Addendum No. 2
Solicitation 25-99328
Junction Avenue and St. Marie Street Reconditioning

NOTICE

JUNCTION AVE/ST. MARIE ST. RECONDITIONING

SHEET NO. 17 OF 89 SHEETS

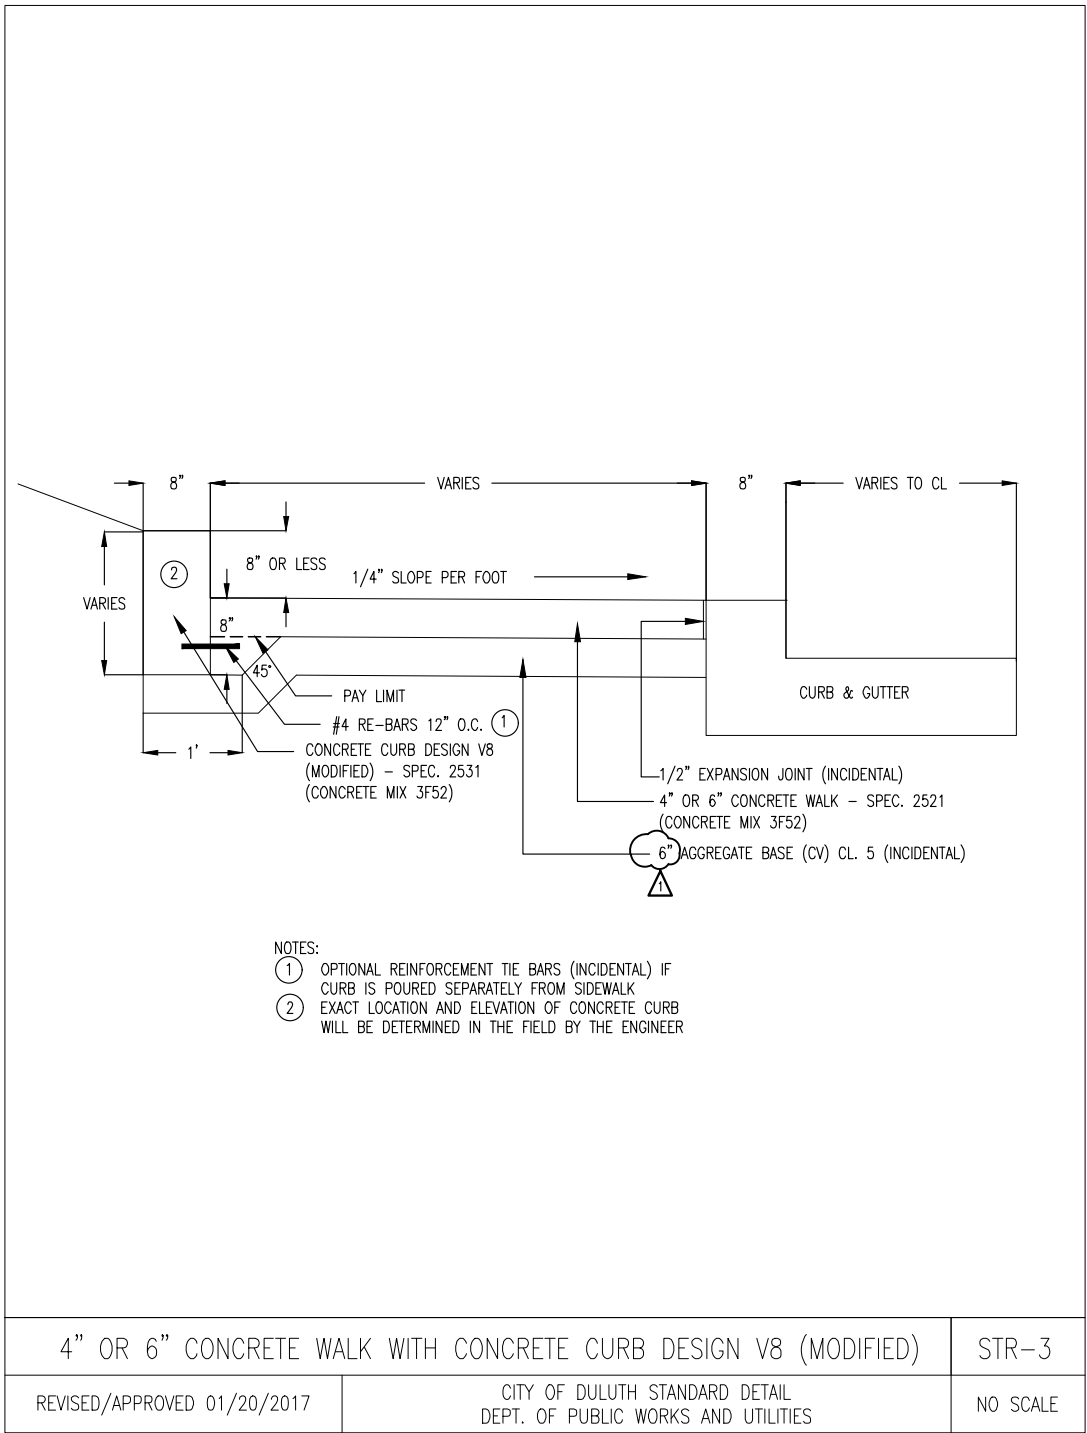
- d. Sheet 17; Delete Sheet 17 in its entirety and replace with revised sheet 17.
Revisions to sheet 17 are as follows:
 - i. PROJECT TOTALS were updated for the following:

- 1. RANDOM RIPRAP CLASS III updated to 22 CU YD.
 - 2. CONSTRUCT DRAINAGE STRUCTURE DESIGN SPECIAL updated to 21 LIN FT.
 - 3. CONSTRUCT DRAINAGE STRUCTURE DESIGN 48-4020 updated to 162.7 LIN FT.

1	03/25/2025	ADDENDUM 01
CONSTRUCTION PLAN		
SHEET NO. 57 OF 89 SHEETS

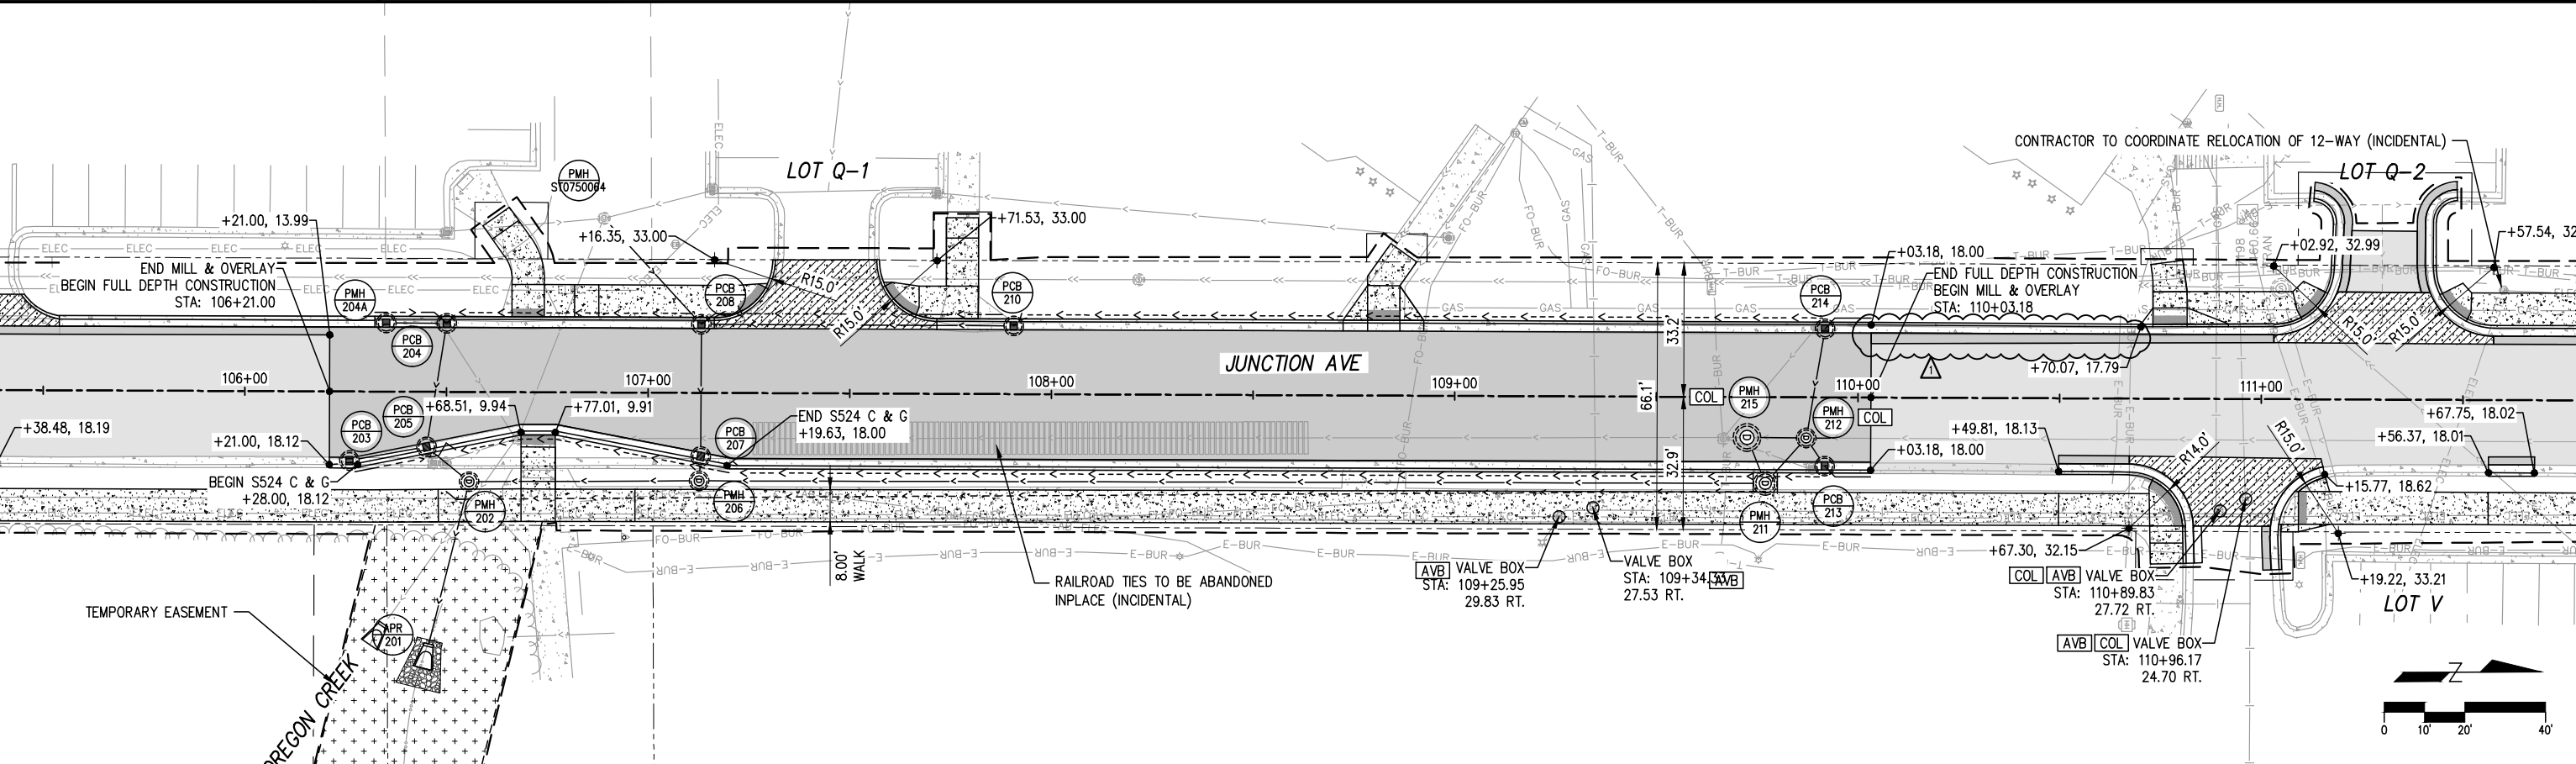
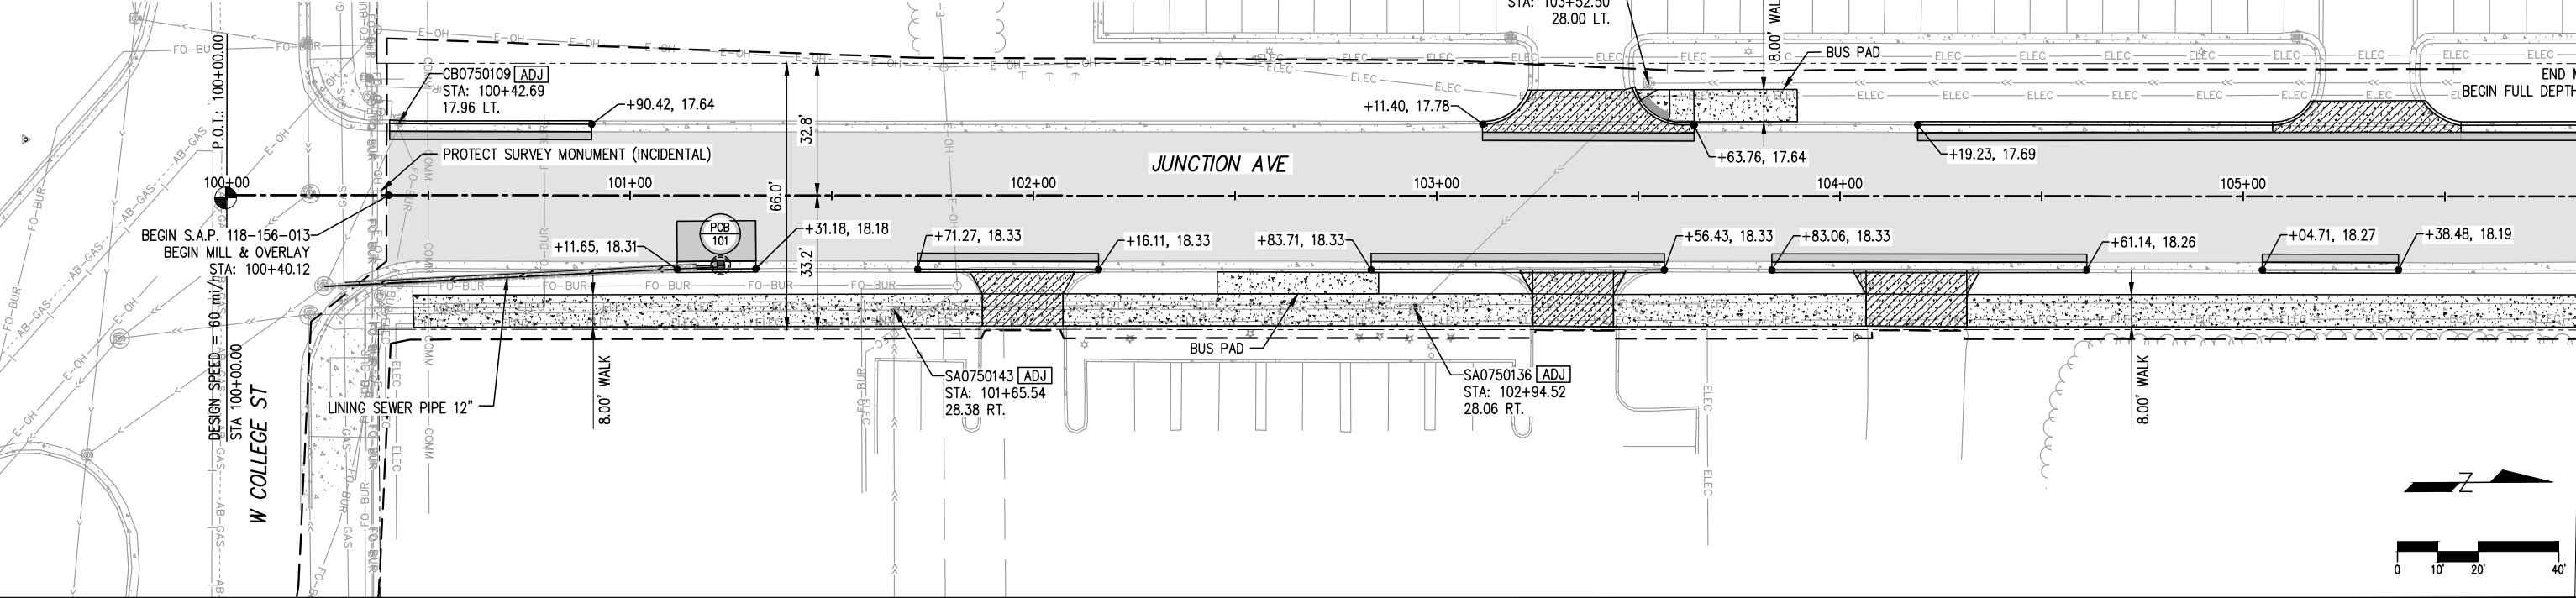
- i. Detail STR-3 Updated to provide 6" AGGREGATE BASE (CV) CL 5 (INCIDENTAL).
5. Drawing changes to the CONSTRUCTION PLAN are as follows:
 - a. Sheet 57; Delete sheet 57 in its entirety and replace with revised Sheet 57
Revisions to sheet 57 are as follows:

- i. Included additional curb for replacement between STA 110+03 and STA 110+70 offset LT.
6. Drawing changes to the INTERSECTION DETAILS are as follows:

1	03/25/2025	ADDENDUM 01
INTERSECTION DETAILS		
SHEET NO. 68 OF 89 SHEETS

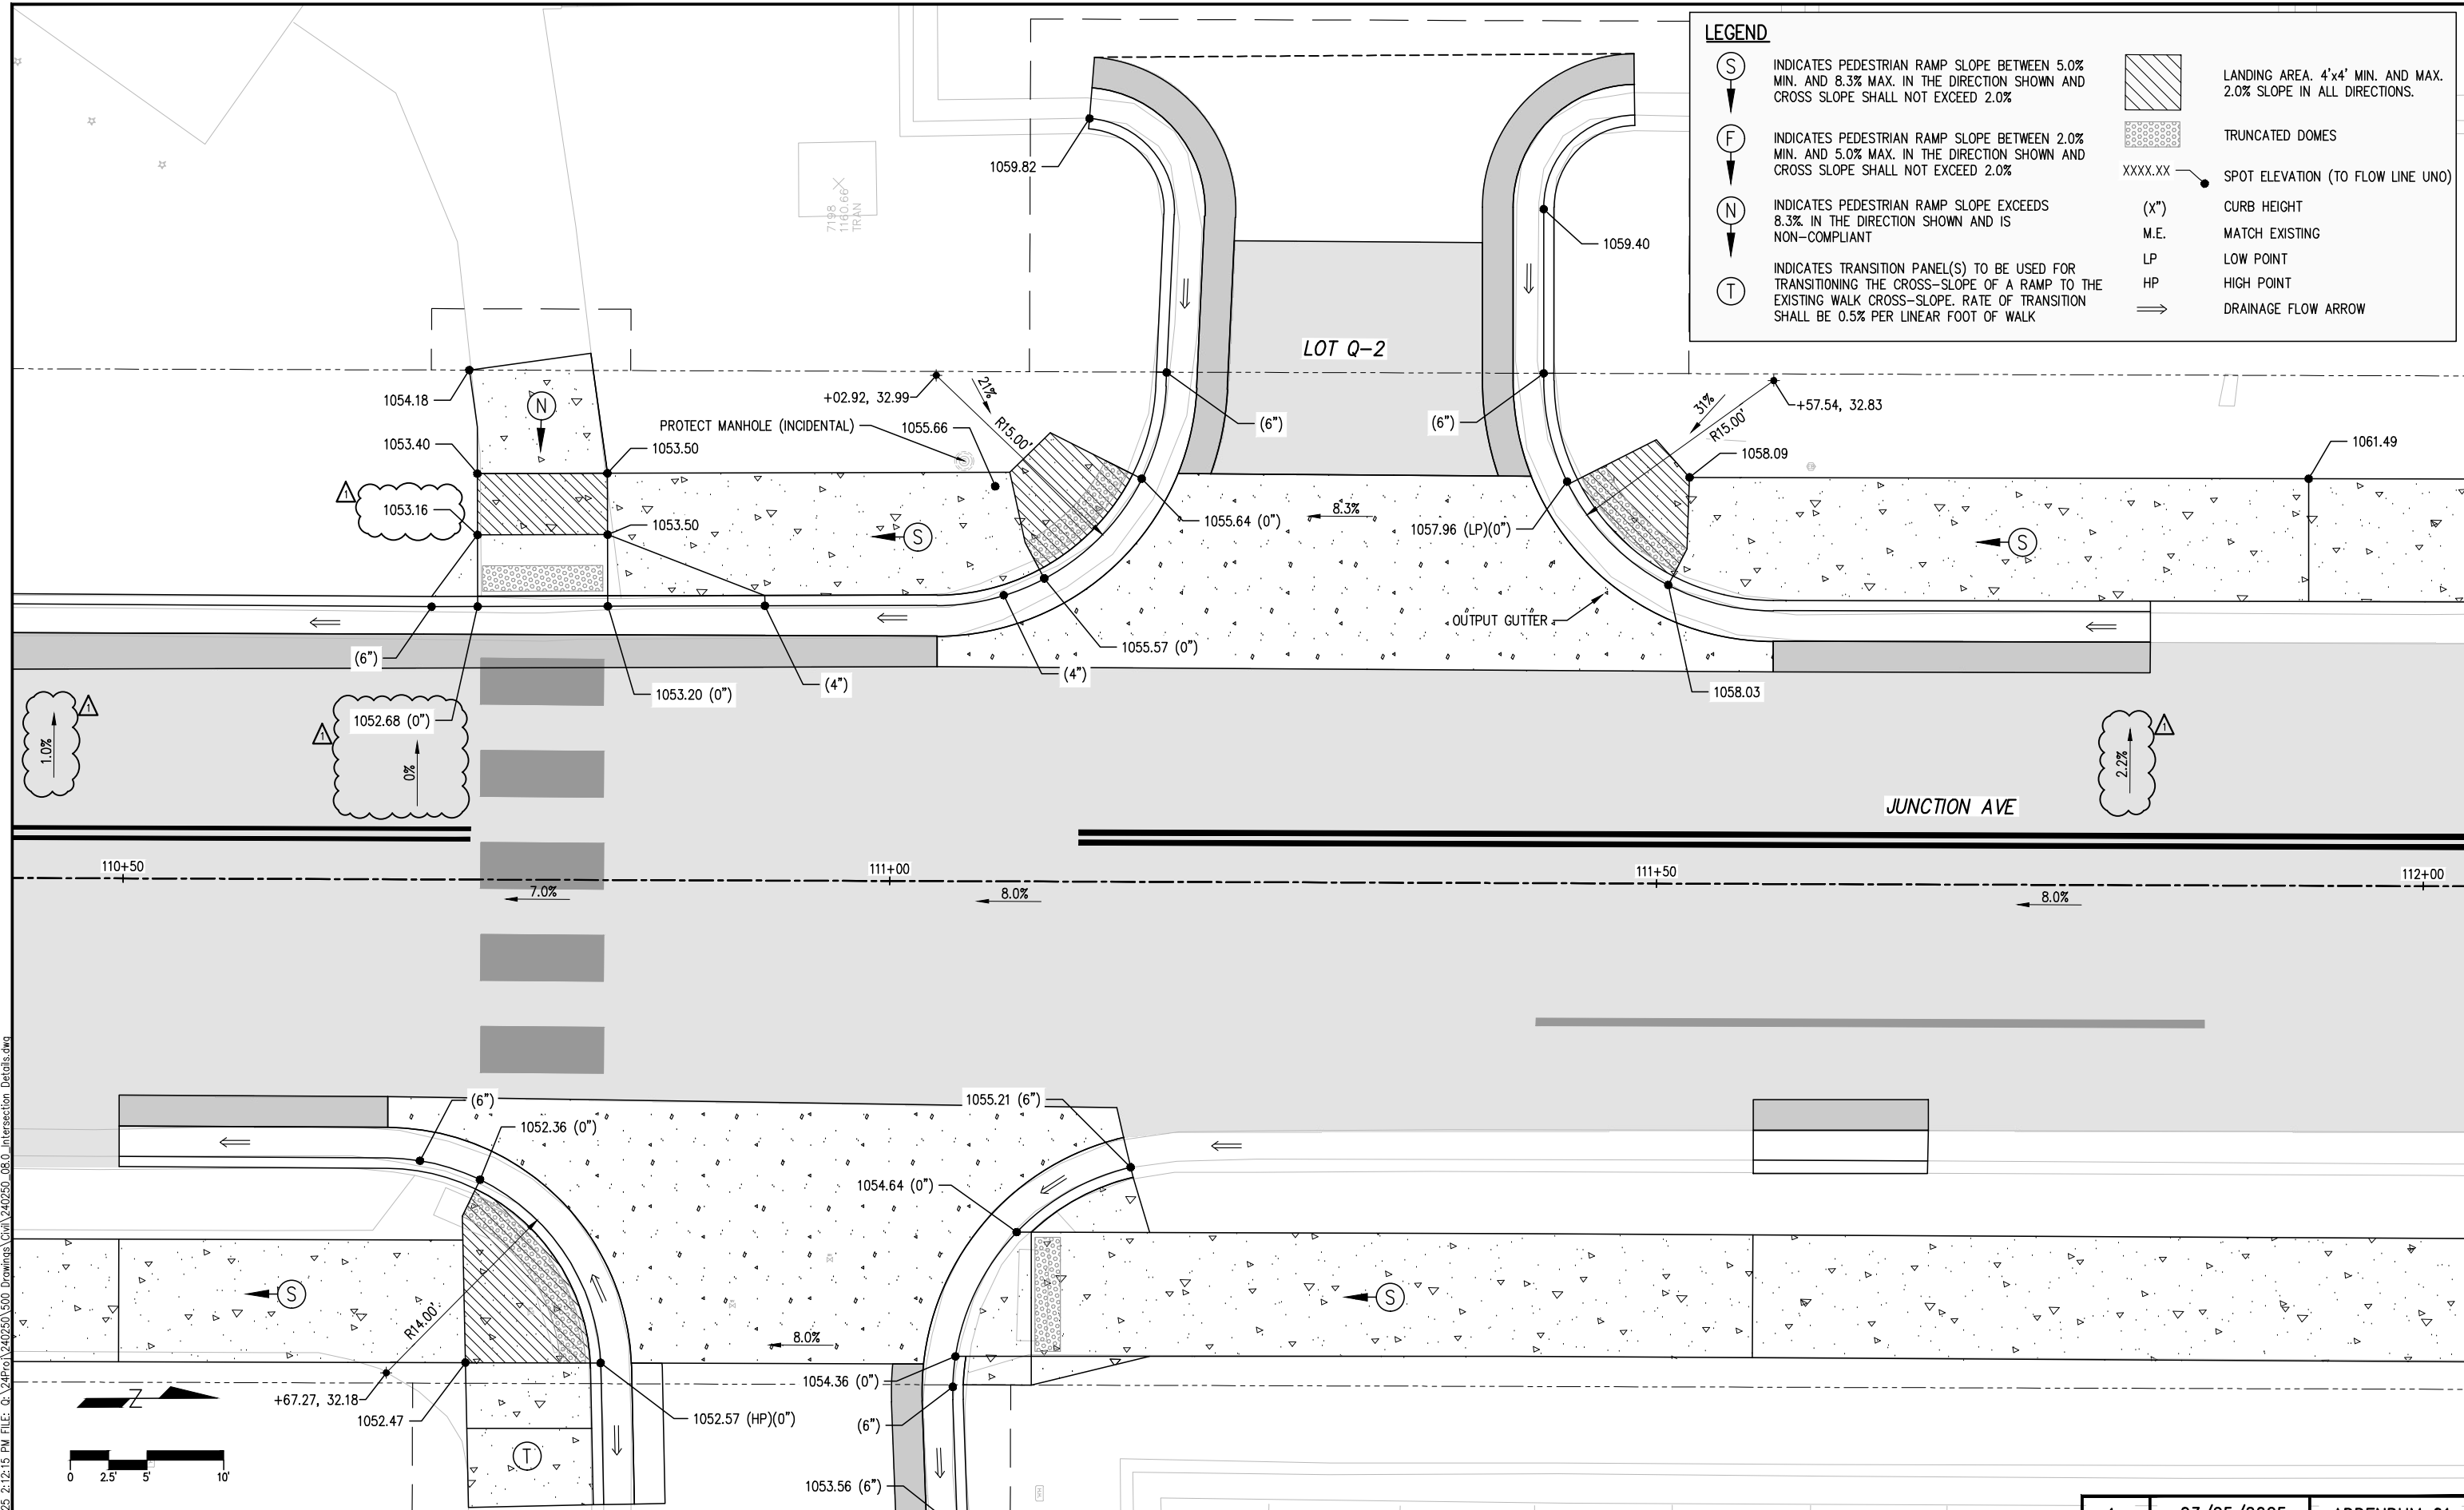
- a. Sheet 68; Delete sheet 68 in its entirety and replace with revised Sheet 68.
Revisions to sheet 68 are as follows:
 - i. Updated elevations in the SW quadrant.

- ii. Updated SB road cross slope information.
7. Drawing changes to the PROPOSED STORM PROFILES are as follows:
 - a. Sheet 77; Delete Sheet 77 in its entirety and replace with revised Sheet 77.
Revisions to Sheet 77 are as follows:

PCB-210 TO PCB-208

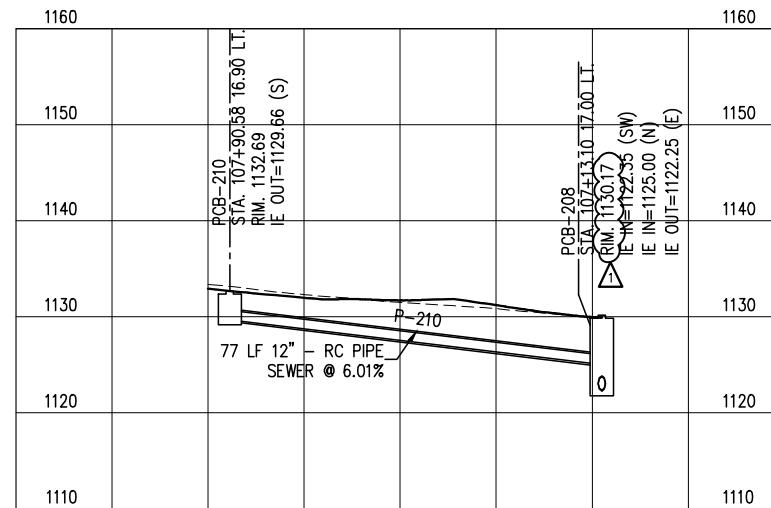
- i. Updated structure number PCB-208 RIM elevation to 1130.17.
8. Drawing changes to the DUCT BANK are as follows:
 - a. Sheet DB01; Delete Sheet DB01 in its entirety and replace with revised Sheet DB01.
Revisions to Sheet DB01 are as follows:
